CHRYSLER A604 (41TE) UPDATE HANDBOOK

INDEX

*Updated
May, 2003*

Figure 15

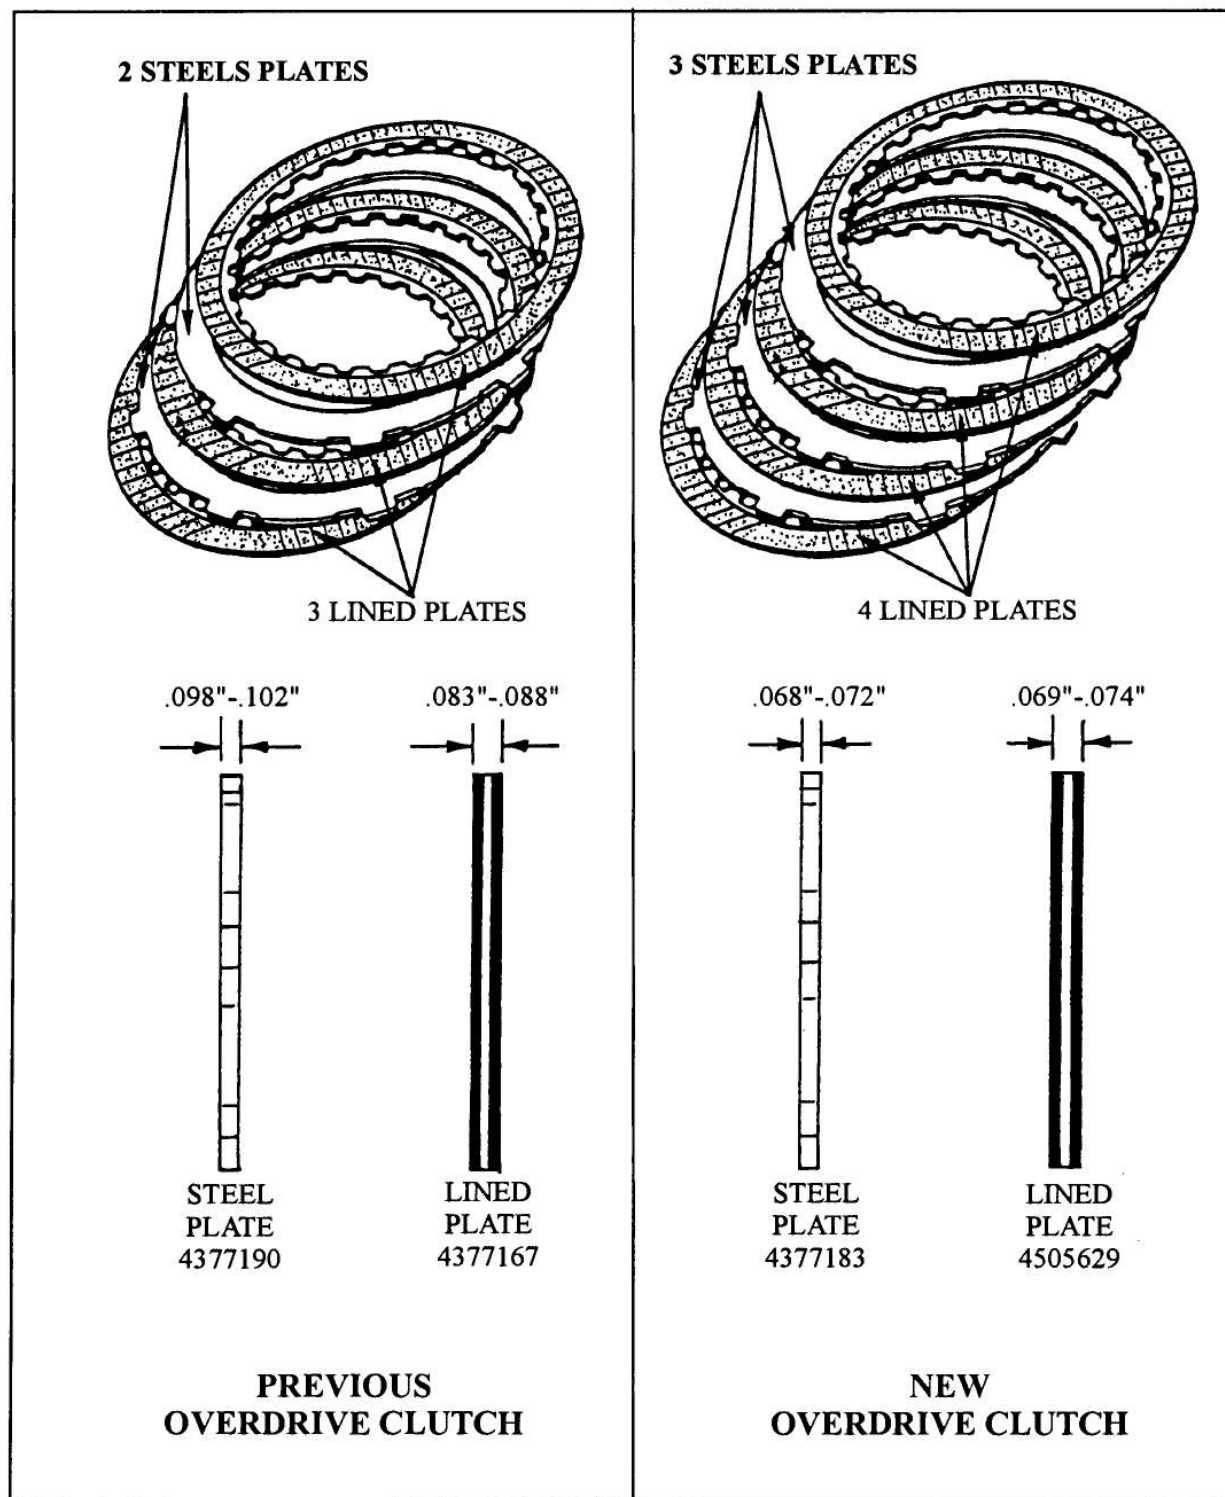
CHANGE: A running change for 1990 model A604 transaxles was the introduction of a four (4) disc Overdrive Clutch Assembly, to replace the previous three (3) disc clutch assembly (See Figure 15).

- (1) **OVERDRIVE LINED PLATES** - Now uses 4 lined plates instead of the previous 3 lined plates, and the lined plates for 1990 models are .014" thinner than the 1989 lined plates (See Figure 15), to help accommodate the extra lined plate. The 1989 lined plates measure .083"-.088" thick, and the new lined plates will measure .069"-.074" thick (See Figure 15).

- (2) **OVERDRIVE STEEL PLATES** - Now uses 3 steel plates instead of the previous 2 steel plates. The new steel plates are .030" thinner, and measure .068"-.072" thick. The previous steel plates measure .098"-.102" thick (See Figure 15).

Figure 16

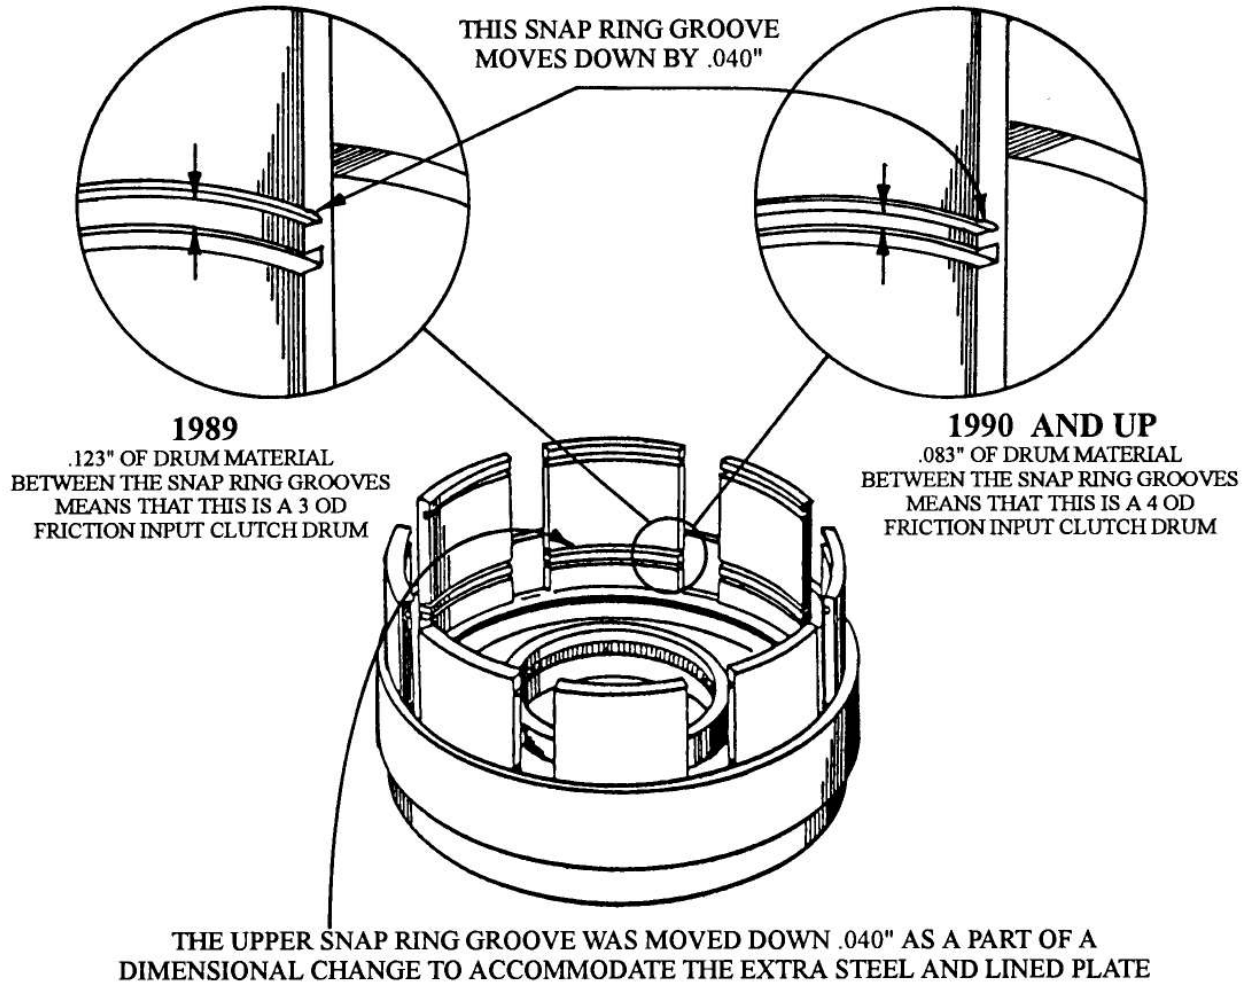
- (3) **INPUT CLUTCH RETAINER** - The underdrive/overdrive reaction plate tapered snap ring groove was moved "Down" by .040" (Can be detected visually) to make room for the added lined and steel plates (See Figure 16). This also necessitated a change to be made to the underdrive/overdrive reaction plate as explained below. Another change that occurred at the same time is the underdrive clutch outer lip seal groove depth is .040" "Shallower" to accommodate a new underdrive clutch outer lip seal (See Figure 17).

1989 INPUT CLUTCH RETAINER.....	4431609
1990 INPUT CLUTCH RETAINER.....	4505623

Figure 17

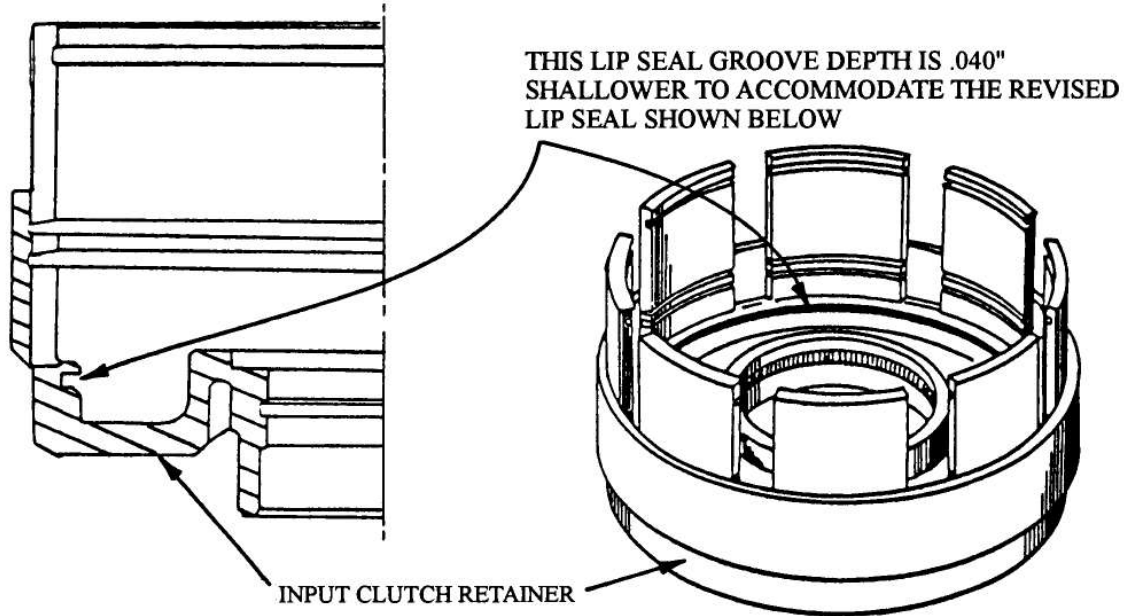
- (4) **UNDERDRIVE CLUTCH OUTER LIP SEAL** - The lip seal cross section has been reduced by .040" (Smaller in Overall Diameter) to accommodate the change in the depth of the groove in the input clutch retainer (See Figure 17). The OEM part number is printed on the seals for identification. The 1989 (Large) is 4377173, and the 1990 (Small) is 4531408. This will confirm that you have the proper seal for this location (See Figure 17).

Figure 28

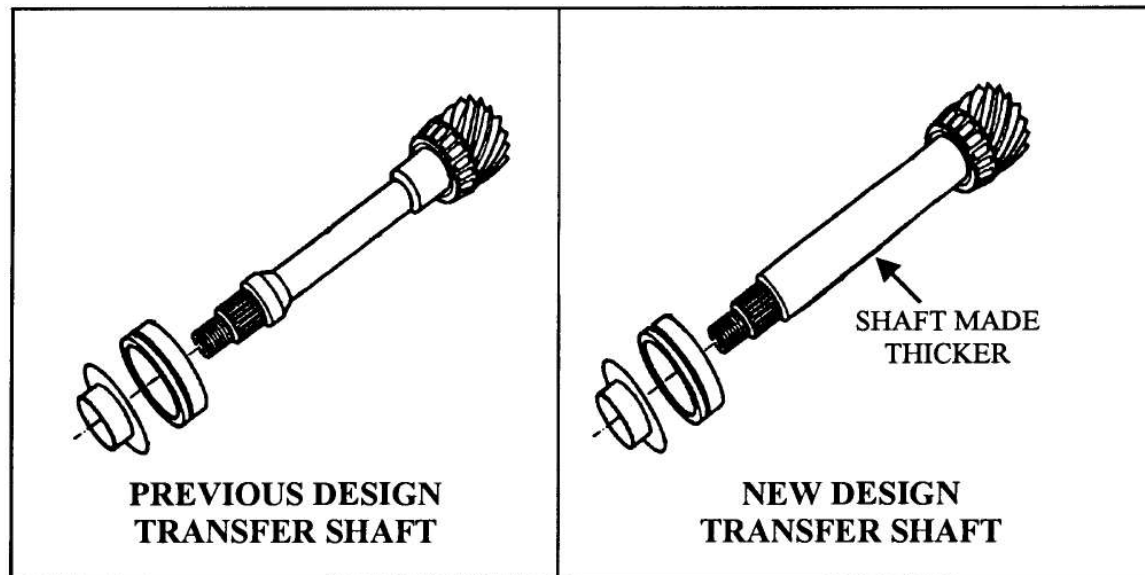
CHANGE: A thicker transfer shaft was made as a running change in 1990 and continues through to current production (See Figure 28).

- (1) **TRANSFER SHAFT** - The transfer shaft between the transfer gear end and the threaded end of the shaft increased in diameter to accommodate torque transfer (See Figure 28).

Transfer shaft, 17 T was part number 4377126 and was superseded to part number.....4531978

Figure 29

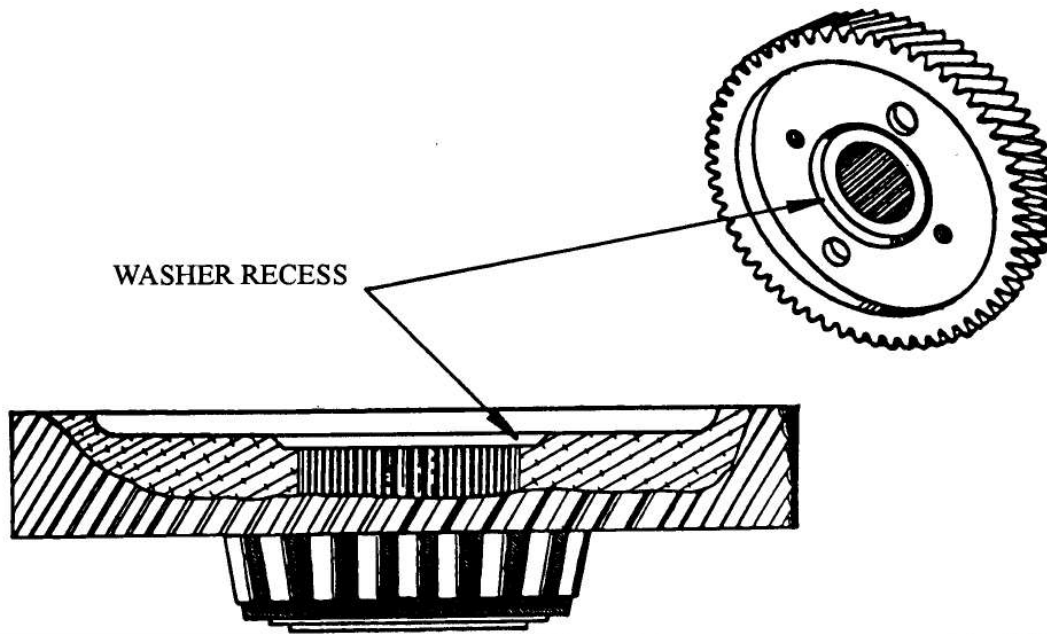
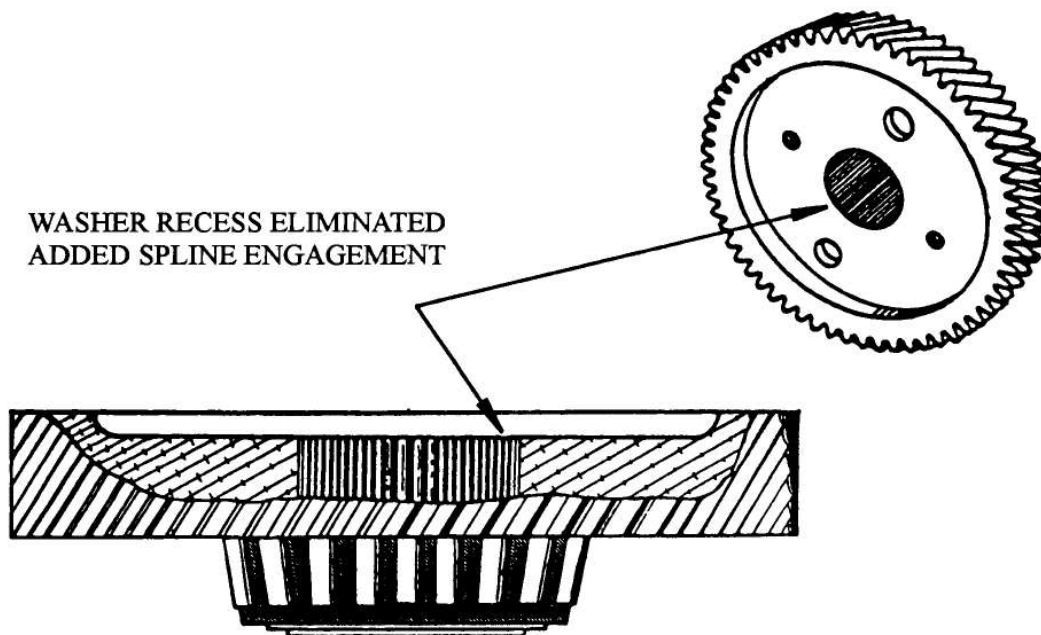
- (1) **TRANSFER GEARS** - The helix angle of the teeth on both transfer gears changed from 27.5 degrees to 32 degrees. The new design transfer gears can be easily identified by the removal of the washer recess area in the center of the gears, as shown in Figure 29. This was done to create more spline engagement, to accommodate higher torque engines.

Figure 30

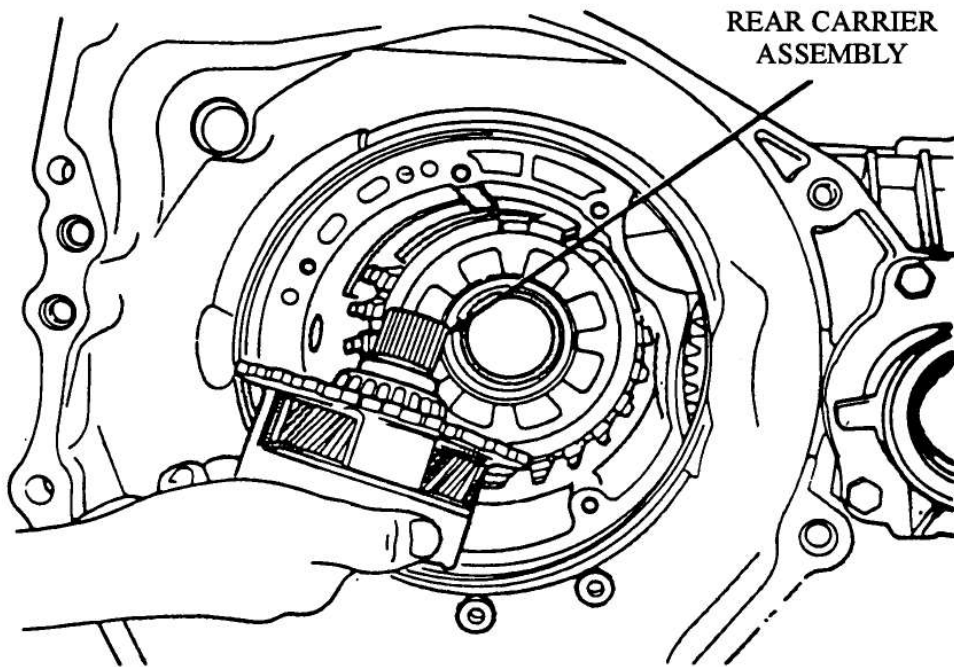
- (2) **REAR PLANETARY CARRIER** - The spline area of the output shaft was increased by 1/8" to accommodate the increased spline area in the transfer gear, as shown in Figure 30.

Figure 33

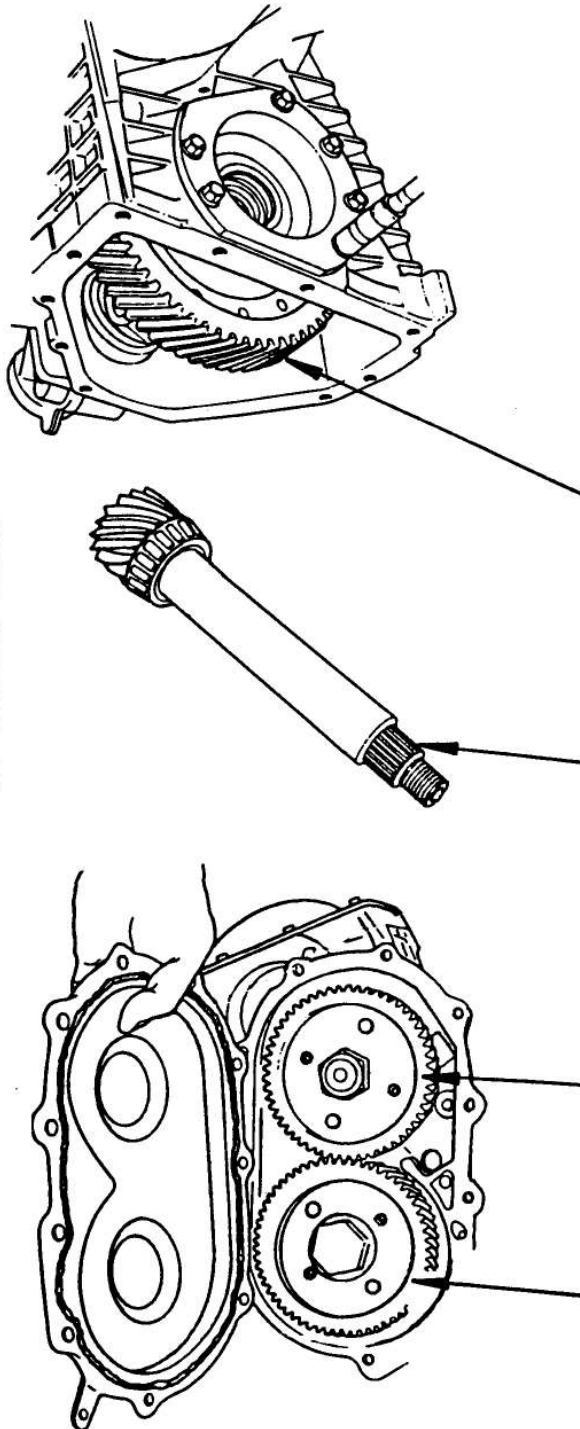
- (6) **OVERALL GEAR RATIO** - New gear ratios come with the upgrade to the 32 degree transfer gears (See Figure 33).

Figure 34

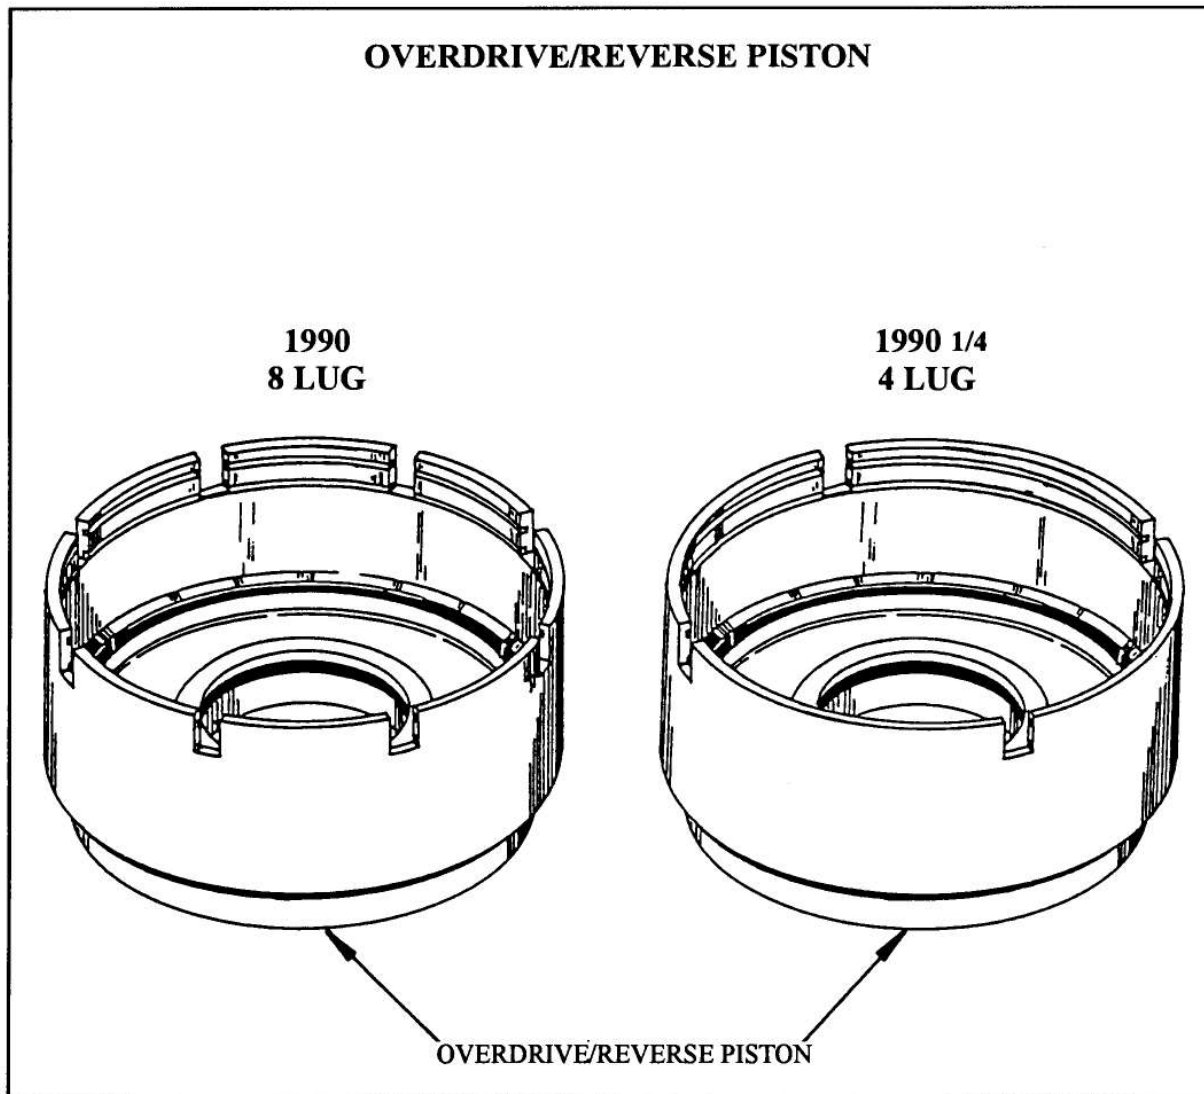
CHANGE: A new Overdrive/Reverse Piston has been introduced for 1990 1/4 model transaxles, and features four reaction plate slots instead of eight slots (See Figure 34).

- (1) **OVERDRIVE/REVERSE PISTON** - The new Overdrive/Reverse Piston has four slots, for the pressure plate lugs, instead of the previous eight slots and can be identified visually (See Figure 34). The inside diameter of the new pistons bottom corner also has a larger radius to accommodate a new 1990 1/4 Input Clutch Retainer dimensional change (See Figure 35).
- (2) **OVERDRIVE/REVERSE PRESSURE PLATE** - The new Overdrive/Reverse Pressure Plate has only four lugs on the outside diameter, instead of the previous eight, and can be identified visually (See Figure 36).
- (3) **INPUT CLUTCH RETAINER** - The new Input Clutch Retainer has a new radius on the outside diameter, to reduce the chance of damage to the lip seal during assembly (See Figure 37). This retainer has no identification marks, and is tough to identify visually. The OEM part number did not change.

Overdrive/Reverse Piston, 4 Slot	4531492
Overdrive/Reverse Pressure Plate, 4 Lug	4531556
Service Package, 4 Lug (Includes Both of the Above).....	5241063
Overdrive/Reverse Piston, 8 Slot	4431613
Overdrive/Reverse Pressure Plate, 8 Lug	4377191

Figure 37

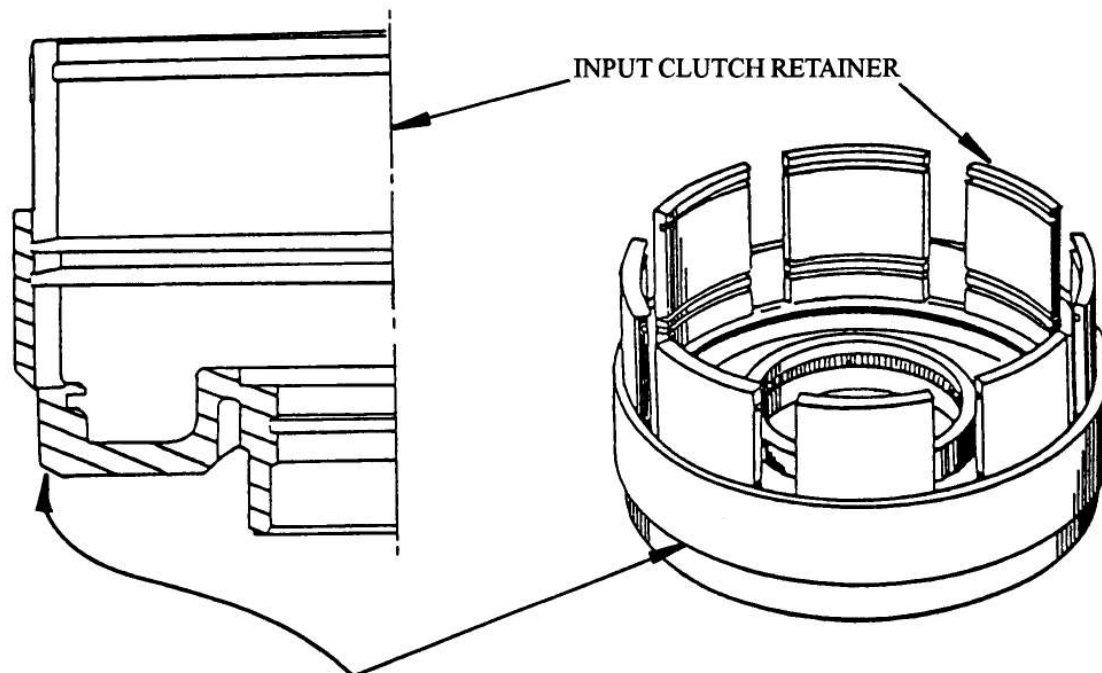
1990 1/4 INPUT CLUTCH RETAINER HAS A REVISED
RADIUS LOCATED HERE, ON THE OUTSIDE DIAMETER
TO REDUCE THE CHANCE OF DAMAGE TO LIP SEAL
